Technical Service Bulletin

Bulletin No.: REC-004-23

Subject: Electronic Parking Brake May Fail

Applicability: Certain 2021-2022 Xos SV05 vehicles

Image 3-1: Remove the Wilwood module

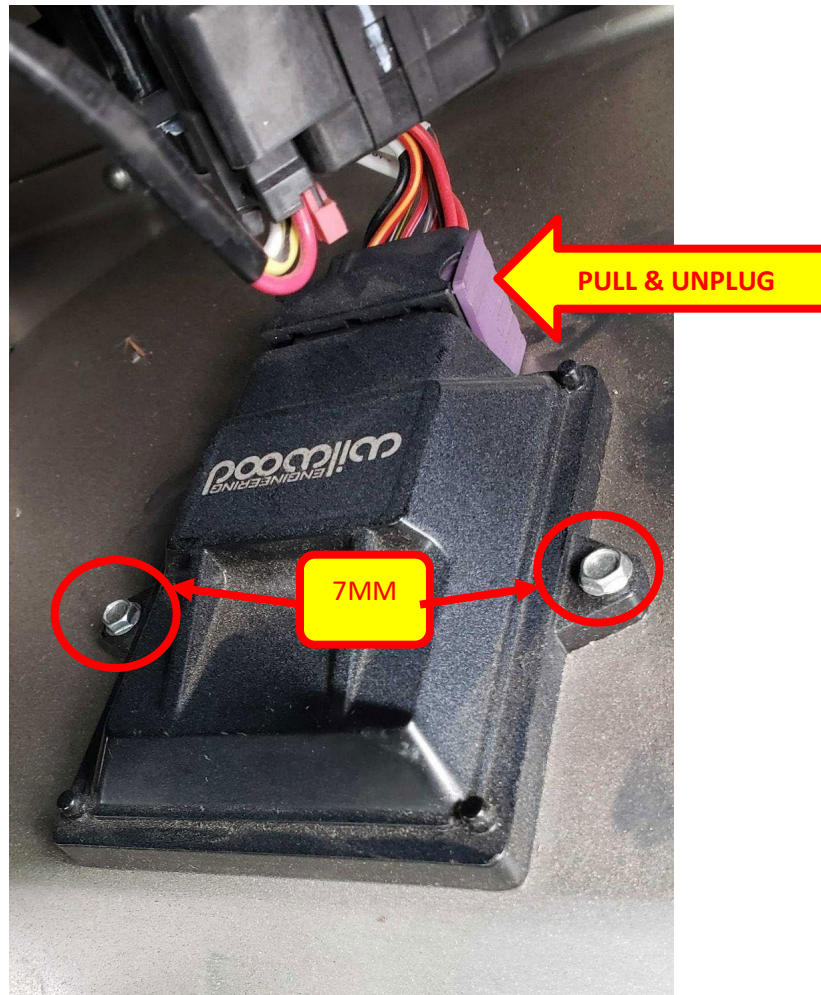
3. Remove the current Wilwood EPB Module.

- On the current EPB Module, pull the purple security lock and unplug the module.
- Remove the two (2) self-tap screws with a 7mm socket wrench and set the screws aside (they will be re-used).
- Remove the current Wilwood EPB Module from the base of the underside of the passenger-side air vents.

Image 4-1: Replacement Module with etched “A” marking

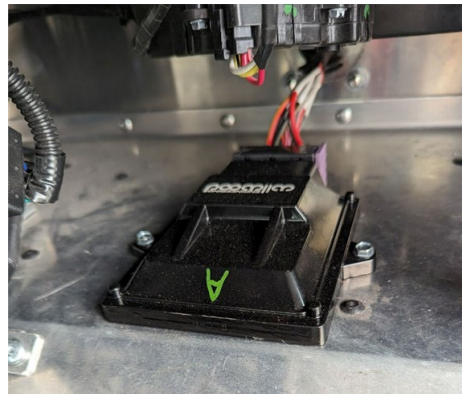
4. Locate the new Wilwood EPB Module that will be the replacement.

- It will be marked in one of three ways, as described below:
 - with the part number XXX-A-15487 or XXX-R-15487 stamped at the top of the module as shown in image 4-1 below;
 - with a green “A” as shown in Image 4-2 below; or
 - stamped with an “R” either before or after the SN as shown in Image 4-3 below.

Image 5-1: Replacement Module intact

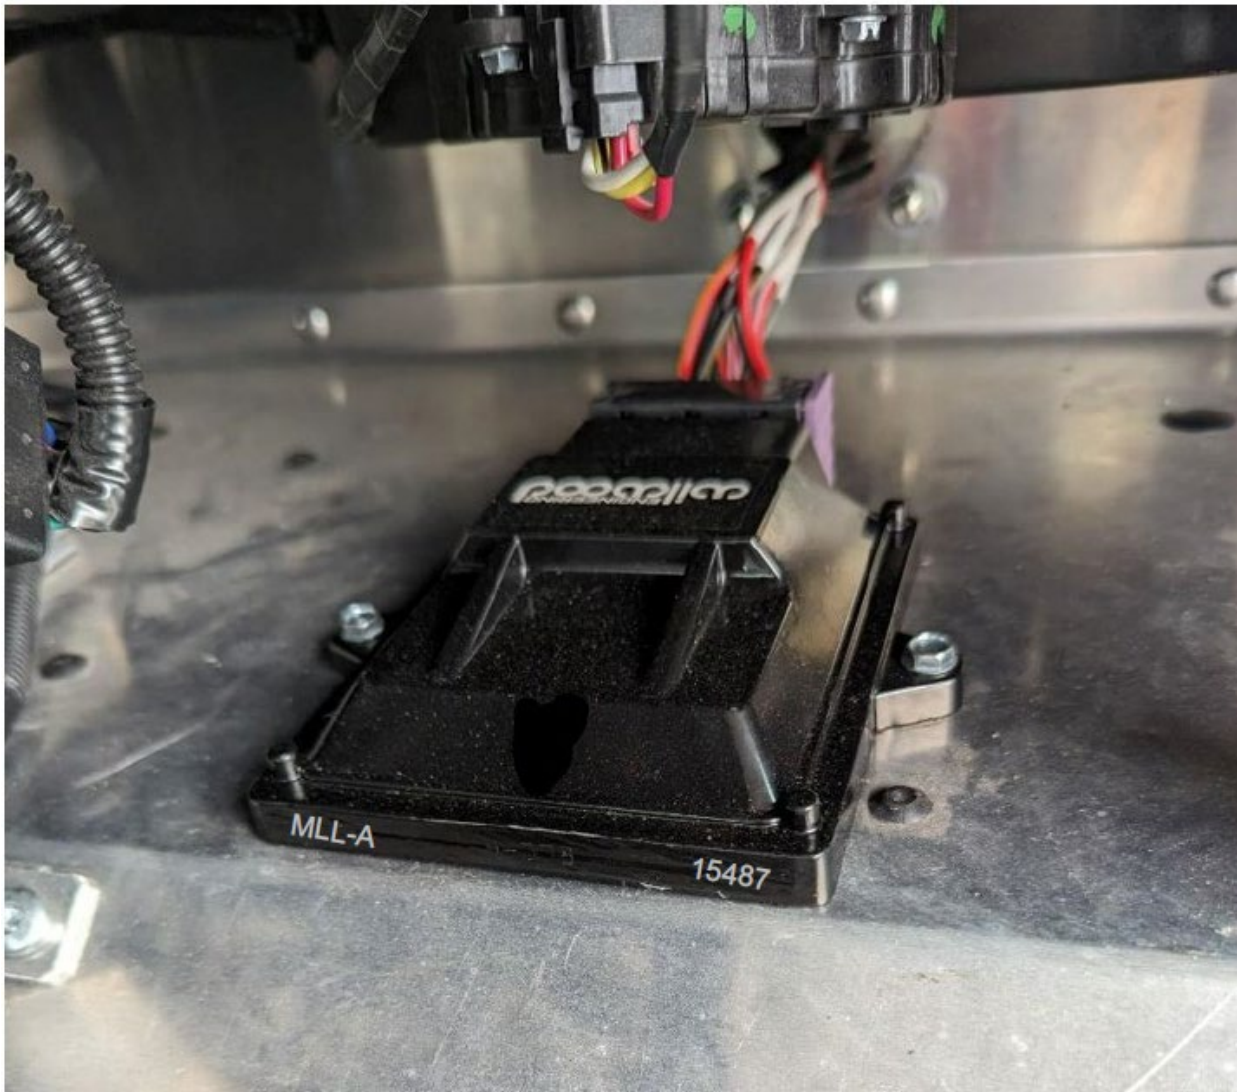
5. Install the new replacement Wilwood EPB Module.

- **Attach the replacement EPB Module to the base of the underside of the passenger-side air vents. Plug the module back in and re-insert the purple security lock.**
- **On the replacement EPB Module, insert the two (2) self-tap screws and hand tighten with a 7mm socket wrench.**
- **Verify that the new replacement Wilwood EPB Module is securely attached.**
